26 November 2018

Our ref: 2316484  
Your ref:

**Enirgi Power Storage Recycling (EPSR) Consolidation Project EIS (SSD 6619),  
Response to Submissions Report  
Additional response to DP&E enquiries**

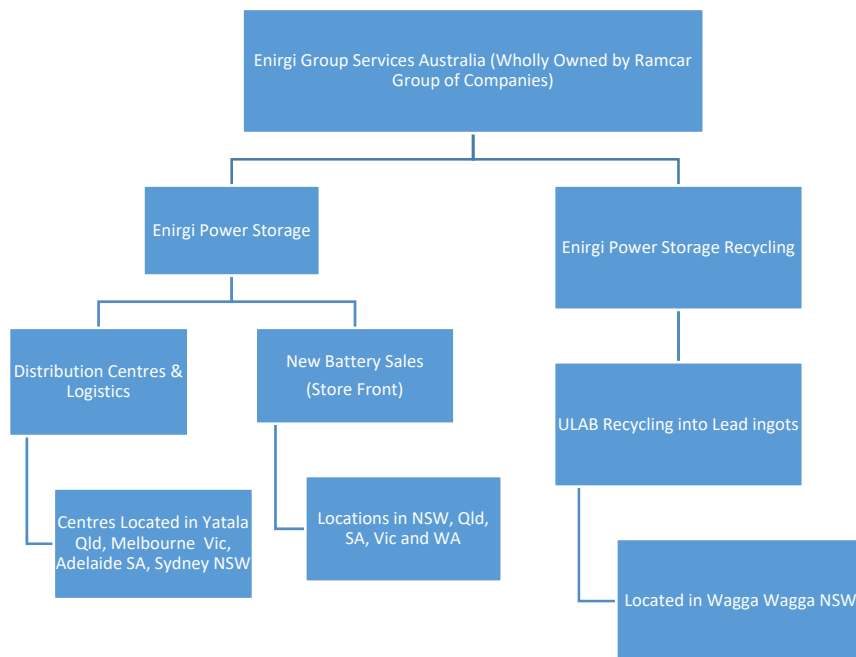
**What consent does the administration building operate under and can the development operate without the administration component?**

Corporate administrative functions for EPSR are located on Lot 3 DP 594679, in the building off East Bomen Road. The building is located in the eastern portion of the site and was approved as part of the original Buckman's laboratory development in the 1990's.

The administration building serves corporate management functions such as finance and human resources and is not directly associated with the operation of the recycling operations. The administration building effectively functions as a corporate head office and could realistically be located at any location around Australia to serve that purpose. Co-location at Bomen provides opportunities for management oversight of the operations and to utilise meeting facilities for site visitors separated from the industrial operations.

Operational management of the site is maintained in the site office adjacent to the car-park within the ULAB facility.

Plans

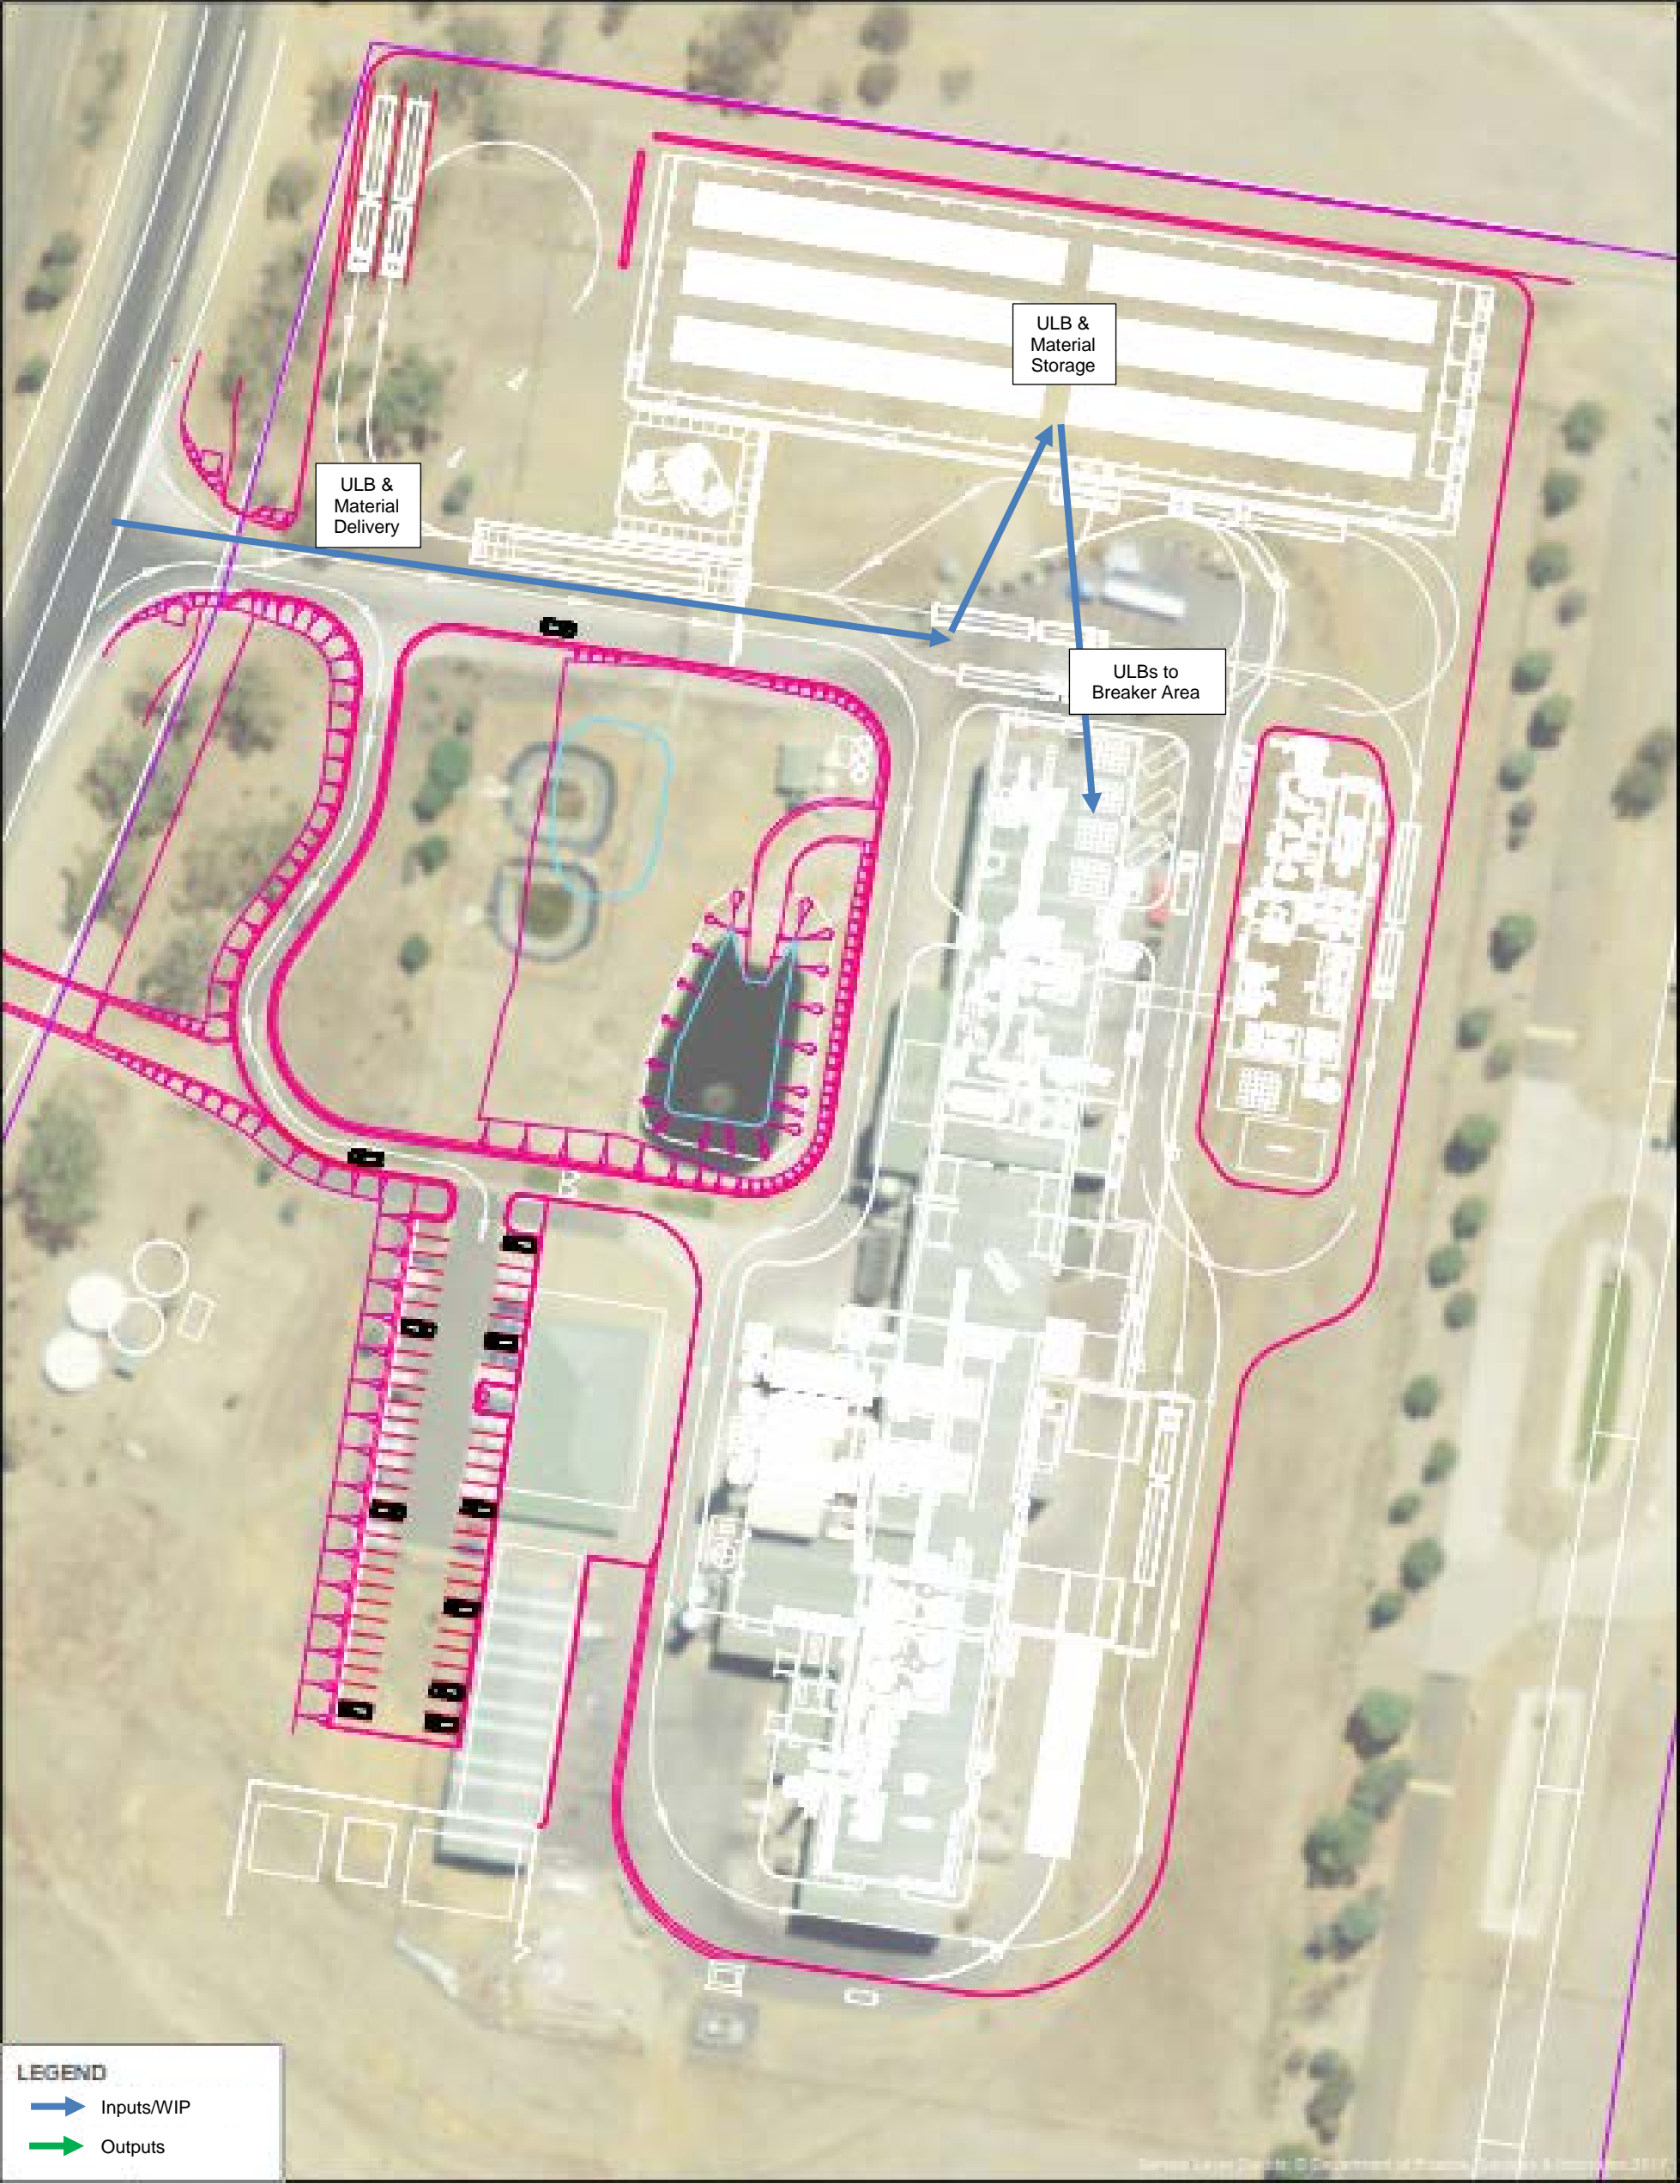
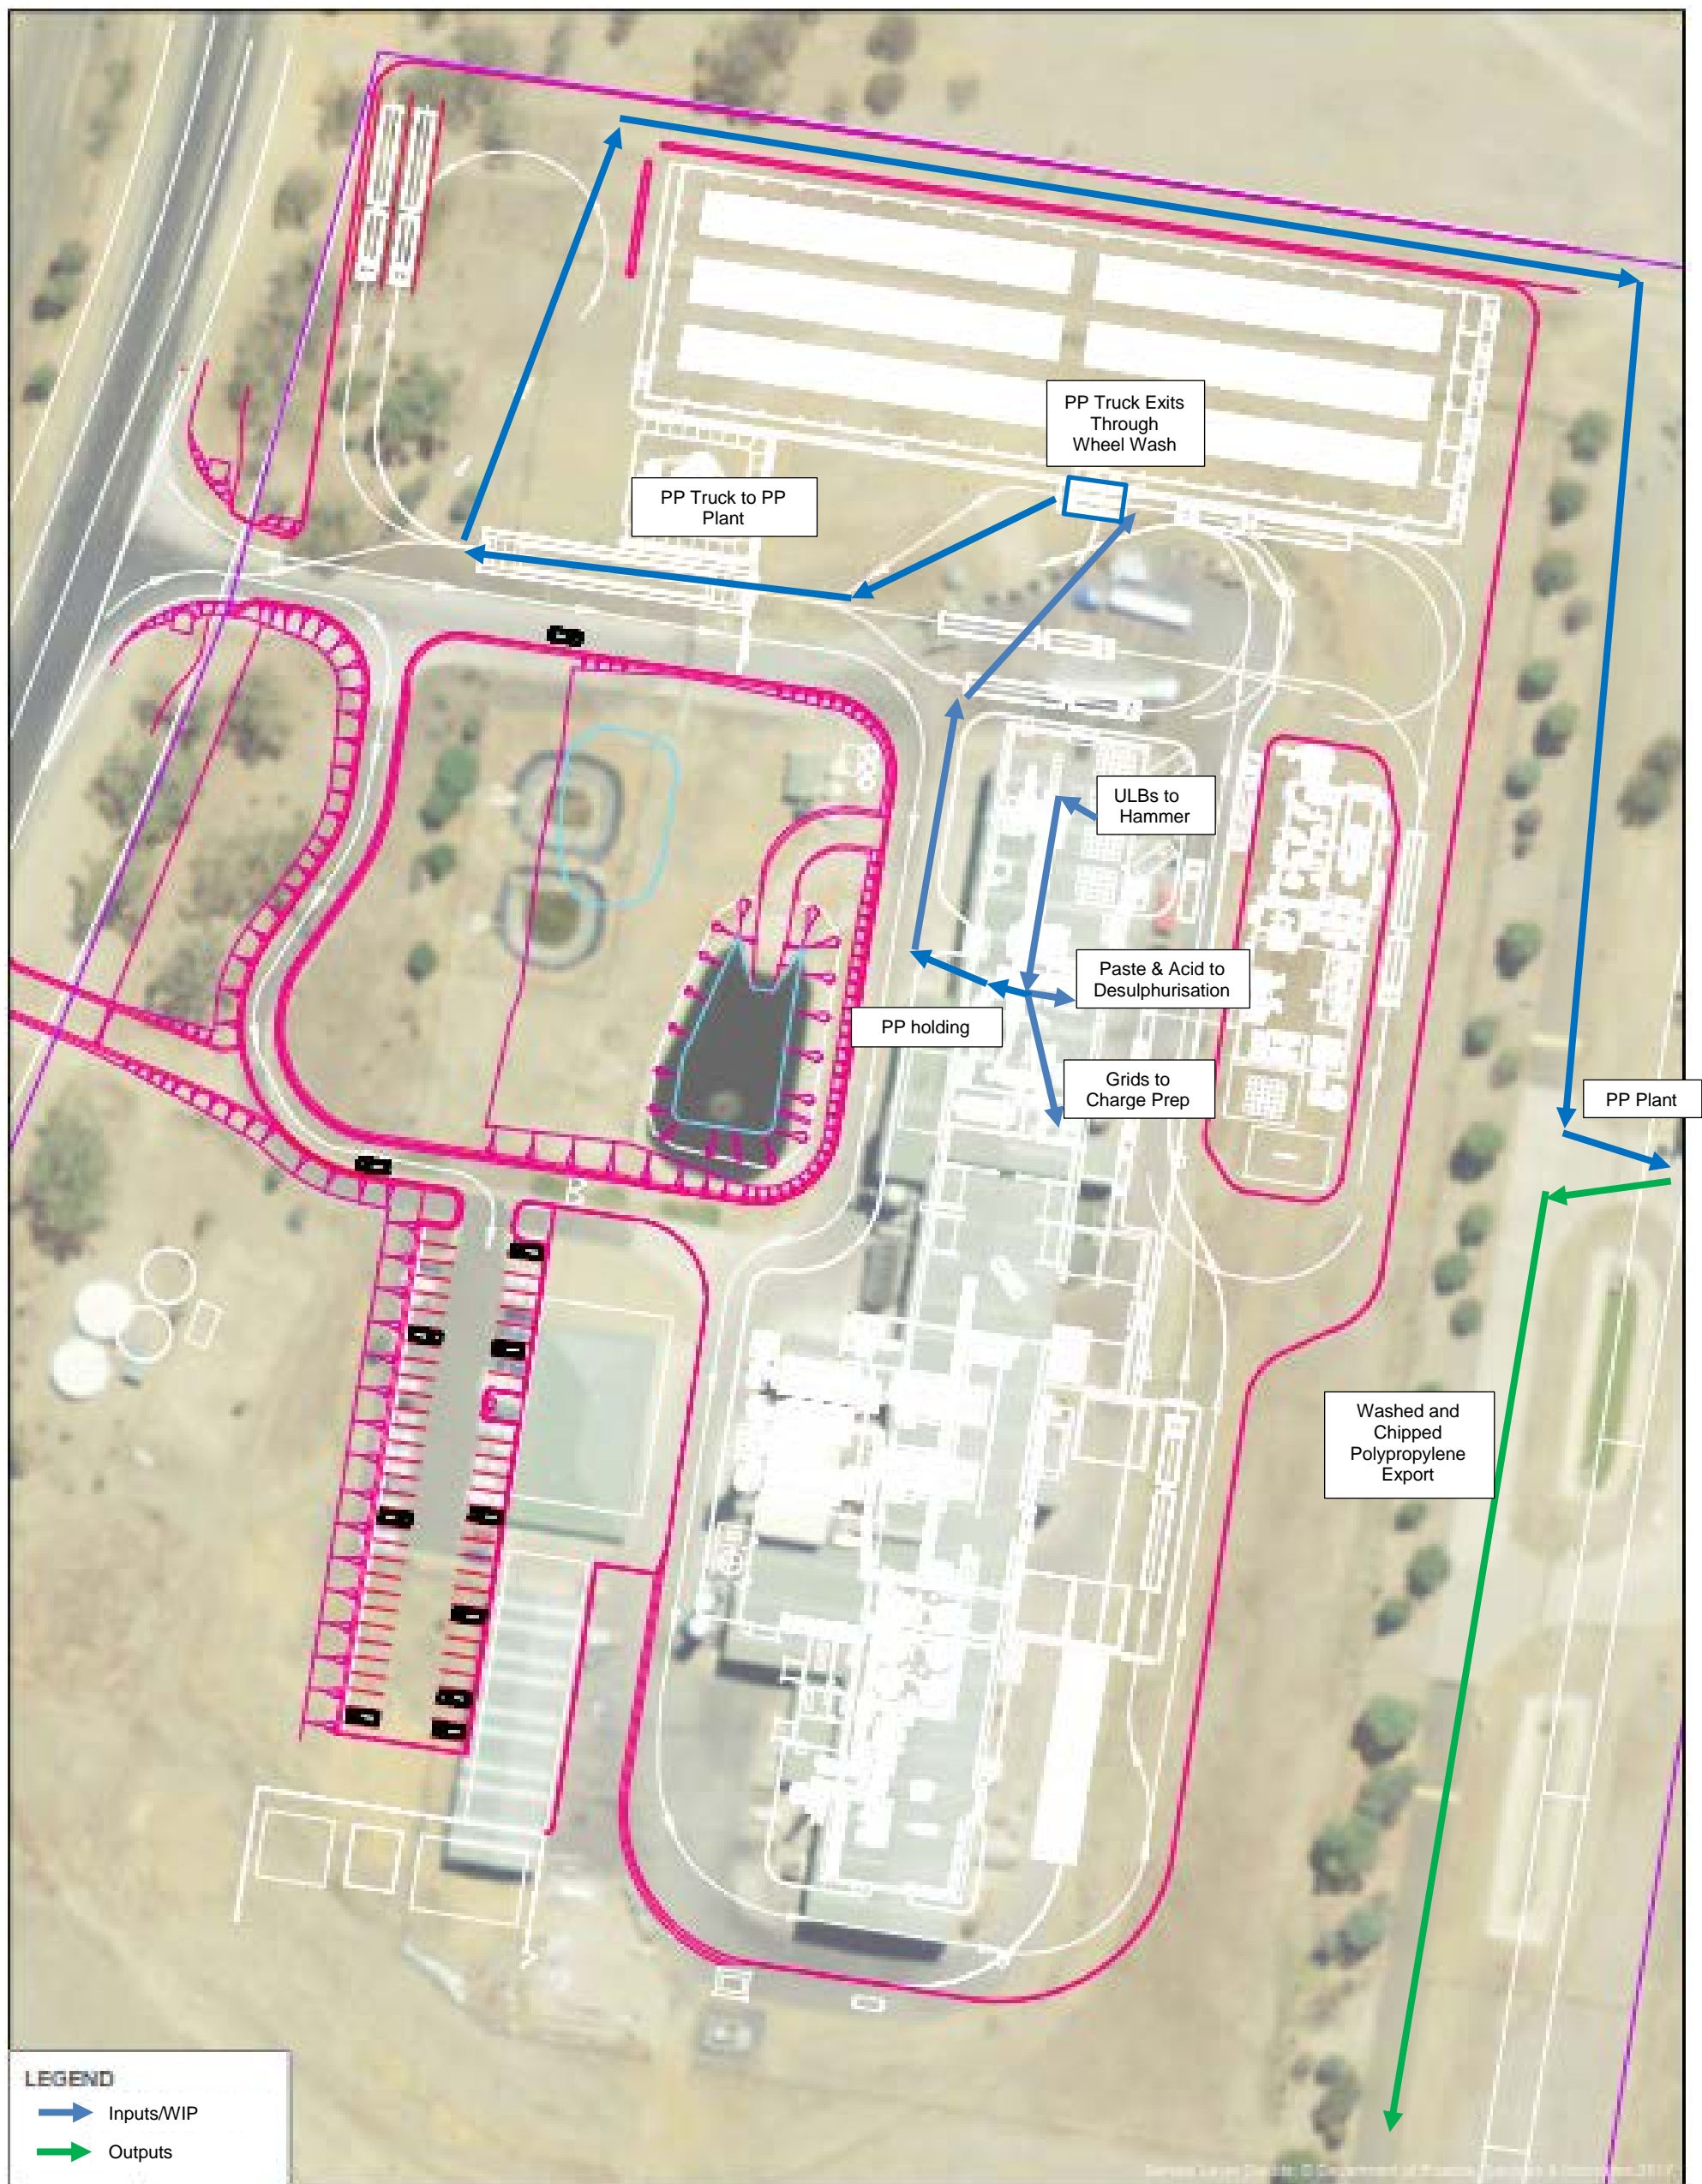
- **updated annotated plans including a plan of the existing site. Please ensure that the plan of the development includes all components of the proposal (including the informal car park, administration building and stormwater detention basin) and that all plans are legible when zoomed in**

Please annotate and include the plastics facility on the general site plan of the proposed development

Provide detailed plans of the plastics facility

- **plans of the new internal roads**  
Provide plans of the new internal roads
- **an annotated engineering drawing of the plastics recycling facility including all components**  
Please provide
- **annotations on relevant plans to show the process flow.**  
Please provide the plan as requested above.

Figure 4-3 in the EIS clearly shows an annotated plan of the PRRF, and Figure 3-4 of the Response to Submissions is an annotated drawing of the key features and proposed new infrastructure of the ULAB facility. This information was presented in two separate figures to allow sufficient detail and visibility.

A new figure showing the information on one single site plan figure has now also been provided as Attachment 2.

Ground Floor Plans of the PRRF have been provided in Appendix D of the EIS. These plans are the same plans that formed part of the Development Consent (DA16/0386) for the PRRF and are all that are currently available. There are no changes proposed to the PRRF, however annotated engineering drawings are now being prepared and will be forwarded within the next week.

As mentioned in section 3.1.2 of the Response to Submissions, concept level design of the new internal roads has been provided in Appendix C of the Response to Submissions Report. This is considered sufficient detail to define the potential environmental impacts associated with the development and is commensurate with the requirements of the Environmental Planning and Assessment Regulation 2000, and typical of the level of detail that is provided in other SSD applications.
